RISO Parts Change Information

Subject: GR Clamp Magnet **ISSUE NO.: 087**

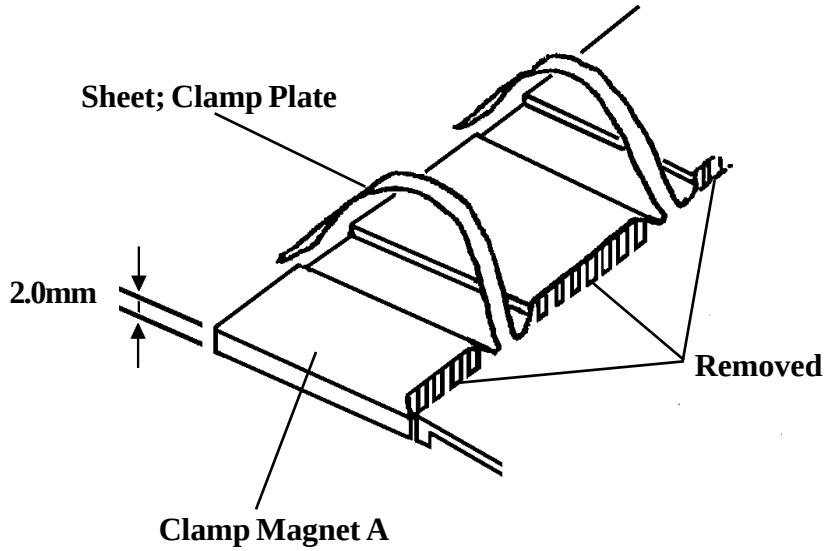
The thickness of the Clamp Magnet has been changed from 1.5mm to 2.0mm.
The shape of the Sheet; Clamp Plate has been changed.

The change prevents Master Slipping during excessively long printing runs.

002-12110-205	Clamp Magnet A
011-12132-704	Sheet; Clamp Plate
